CHARLOTTE - MECKLENBURG
PLANNING COMMISSION

SUBJECT: Administrative Approval for Petition No. 2006-22 by Live Oak Development Partnership, LLC.

Live Oaks Property
REZONING ADMINISTRATIVE
APPROVAL
DATE: August 16, 2006
BY: DEBRA D. CAMPBELL

Live Oaks Property Rezoning

Technical Data Sheet

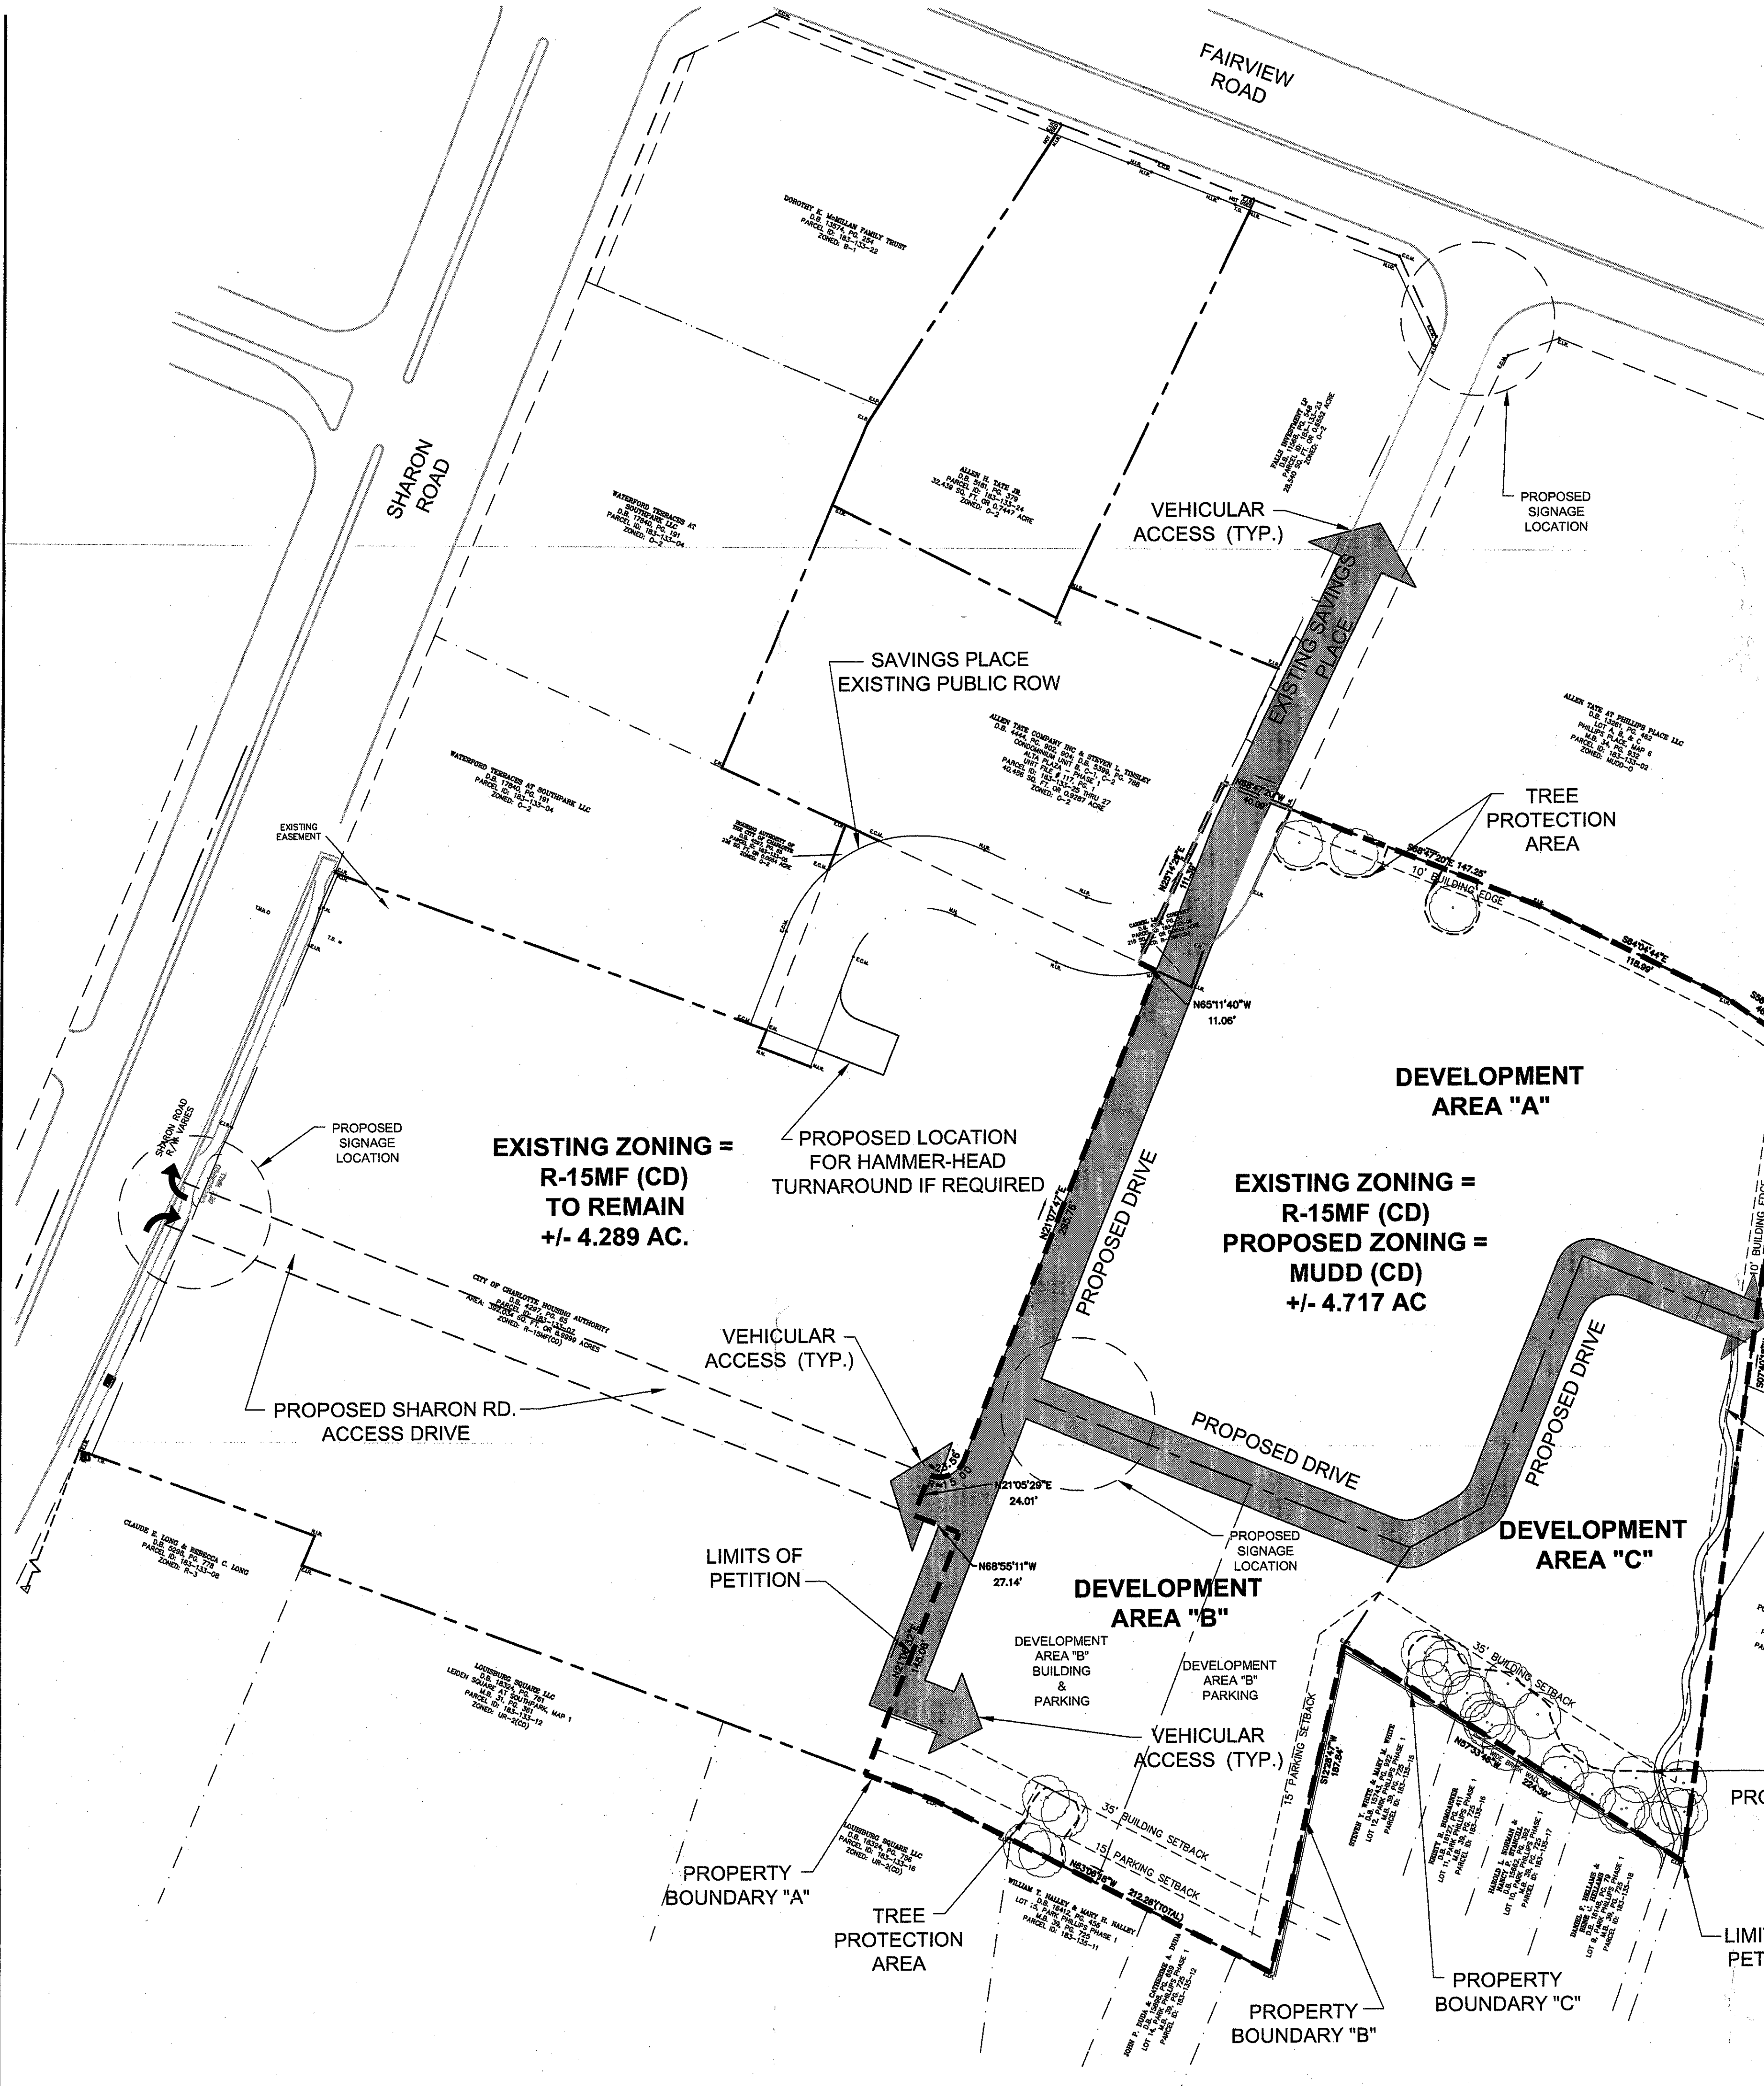
Attached are revised plans for the above petition. The plans have been revised to allow balconies, within buildings constructed within area "B", on the first and second level facing south toward boundary "A". Since this change is minor, I am administratively approving these revised plans. Please use these plans when evaluating requests for building permits and certificates of occupancy.
